LAND AT BATCHELORS FARM, KEYMER
ROAD, BURGESS HILL

STAGE 1 ROAD SAFETY AUDIT
RESPONSE REPORT

Project Title:	Land at Batchelors Farm, Keymer Road, Burgess Hill		
Client:	SDP		
Project Manager:	Michael Kitching		
Project Number:	SK21799		
Document Reference:	SK21799_2026RSARR02		
Document Type:	Road Safety Audit Response Report		
Primary Author:	Michael Kitching		
Approval Signature: Michael Kitching			
Directory & File Name:	P:\2017\PROJECT FOLDERS\SK21799\Technical\Reports\SK21799_RSARR02		
Issue	Date	Distribution	Comments
01	14/01/26	Project Team	Final Report
02	14/04/26	Project Team	Updated Report following WSCC Comments

Drawing Title
Vehicle Swept Path Analysis
11.3m Refuse Vehicle

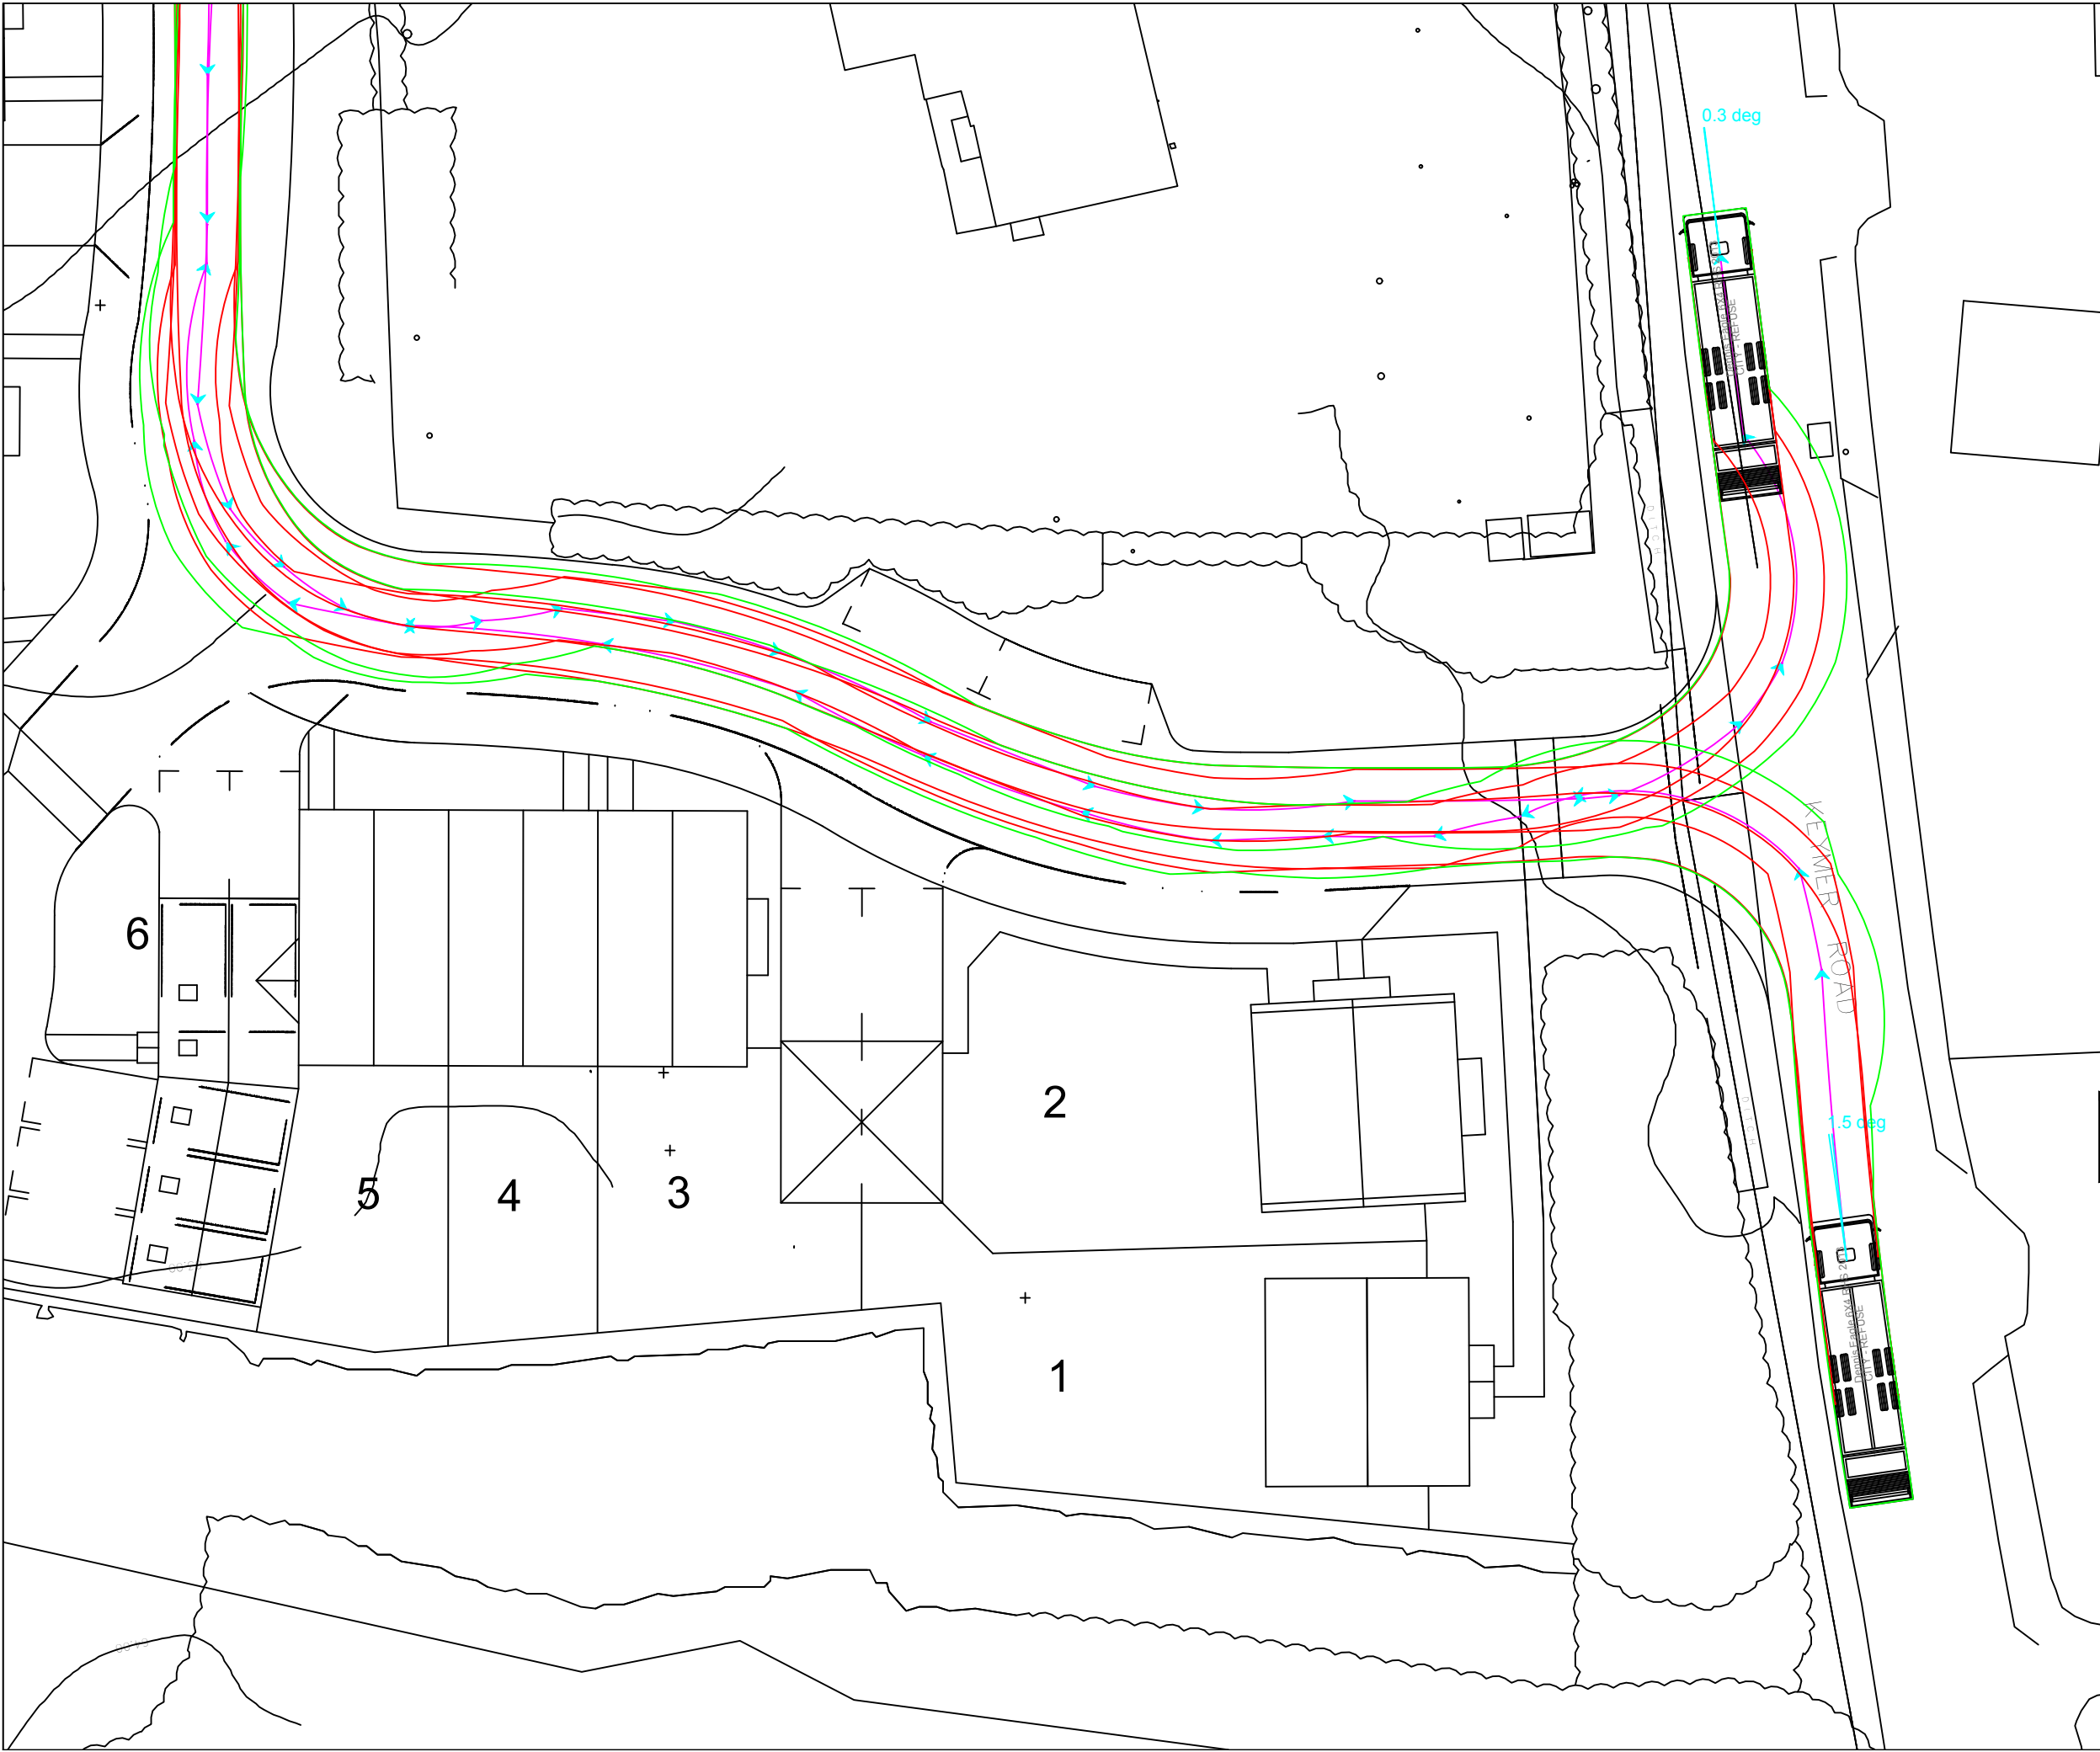
Problem 3: Potential swept path requirements of vehicular traffic accessing and egressing the northern and southern access junctions could result in a potential increased risk of head on or side swipe type collisions occurring

- 2.19 The RSA team noted that scheme proposes two priority junctions on the western side of Keymer Road, and that the potential swept path requirements of vehicles accessing and egressing the development site access junctions could result in vehicles crossing the centrelines within the northern and southern access junctions, as well as the centreline within Keymer Road. As a result they have highlighted that this could result in a potential increased risk of head on or side swipe type collisions occurring, where vehicle occupants could sustain personal injury.

- 2.20 The RSA team has recommended that swept path analysis should be undertaken for all the expected types and sizes of vehicles entering and exiting the development site access junctions, in order to mitigate the above described potential collision scenarios. The RSA team has said that if there is any encroachment over centrelines, then junction geometry should be modified in order to mitigate their described potential collision scenarios.

- 2.21 In response to the RSA team's findings, we have prepared a range of swept path analysis drawings, showing refuse vehicle, private car and fire appliance vehicles entering and leaving the site. These tracking plans are provided in **appendix e**.
- 2.22 In terms of vehicles crossing the centreline of Keymer Road and on the minor junction arms the swept path analysis confirms that all vehicles can enter and leave the site without any wheel overrunning kerbs and grassed areas. The turning areas can all accommodate the refuse and fire appliance vehicles that have been tracked.
- 2.23 With regard to vehicles overrunning the centreline of carriageways, the scheme design has been designed to accommodate slow speeds, and also not over-design the access routes to be vehicle dominated.

- 2.24 As an example, to accommodate a 11.3m refuse vehicle avoid overrunning the centreline of carriageways a priority junction design would need to be designed with 10m kerb radii, and an internal 6m+ carriageway width. This would, in turn run the risk of higher entry and exit vehicle speeds onto/off Keymer Road, which would have a negative effect on highway safety on the Keymer Road corridor, and within the development.

With regards to point 3 (the RSA service vehicle query), I think it's fairly common with housing developments to have the refuse vehicle overrunning the centre line when accessing the development road. It's an infrequent movement and the operatives are used to doing the manoeuvres day in/day out so we are ok with this.
